Technical Bulletin

Bulletin No: TCH-26-001

Subject: **Brake Switch Interface Recall**

Figure 1 – Brake Pedal Clevis Pin Hole

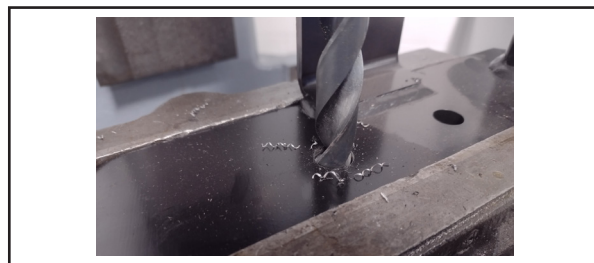
Bendix has determined that the brake pedal, manufactured by a Bendix sub-supplier, may have been manufactured out of specification, thereby causing a potential defect. The clevis pin hole on the brake pedal may be undersized, thereby creating a binding condition that may impede the proper functionality of the brake switch. *Figure 1* shows the affected clevis pin hole on the brake pedal being modified to remedy the problem.

For instructions on replacing the brake switch interface, reference *S-1685, Blue Bird Brake Switch Interface Service Kit*, on b2bendix.com. **NOTE:** It is not necessary to return any replaced parts that are included in the Blue Bird Brake Switch Interface Service Kit.
